Subject: Oconee Nuclear Station
Docket Nos. 50-269, -270, -287
LOCA-Limited Maximum Allowable Linear Heat Rate

Pursuant to 10CFR 50, §50.90, please find attached (Attachment 1) a proposed amendment to the Oconee Nuclear Station (ONS) Facility Operating Licenses and revisions to the ONS Technical Specifications. The proposed revision will update the LOCA - Limited Maximum Allowable Linear Heat Rate (Figure 3.5.2-16) to reflect B&W Owners Group Topical Report BAW2001P, Low Pre-Pressure Fuel Rod Program (Attachment 3).

PROPOSED TECHNICAL SPECIFICATION REVISION

Oconee Nuclear Station
Figure 3.5.2-16

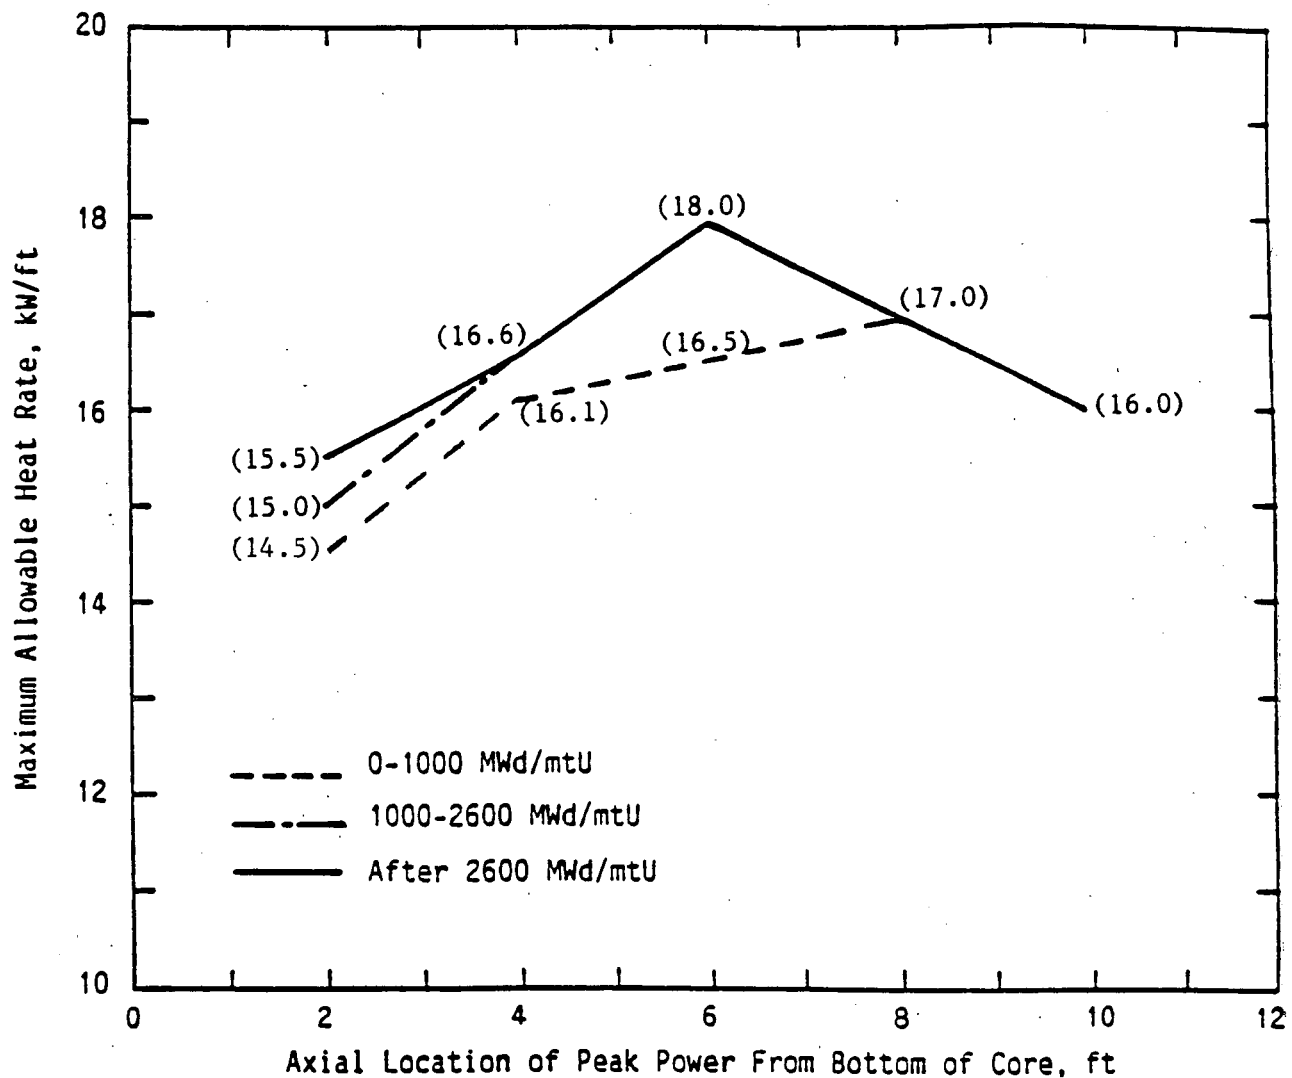
This proposed revision will update the LOCA-Limited Maximum Allowable Linear Heat Rate (Figure 3.5.2-16) to reflect BAW-2001P, Low Pre-Pressure Fuel Rod Program. As such, the previously analyzed accident that is applicable to this change would be a large break loss of coolant accident. Acceptance criteria for this event is identified in 10CFR 50.46 and 10CFR 50, Appendix K. BAW-2001P has been provided in Attachment 3 and provides the Technical Justification for the proposed amendment.

Changes in LOCA margin were evaluated by analyzing the most restrictive LOCA case. This is the peak power at the 2 ft level of core elevation at beginning-of-life (BOL) conditions. This analysis, performed generically for the lowered loop configuration B&W NSSS plant had resulted in an allowable LHR of 14.0 KW/ft for the standard Mark-B design. When redone for the reduced pre-pressure design this analysis verified that an allowable limit of 14.5 KW/ft was achievable. BAW-2001P provides detailed analyses for burnup extension and LOCA.
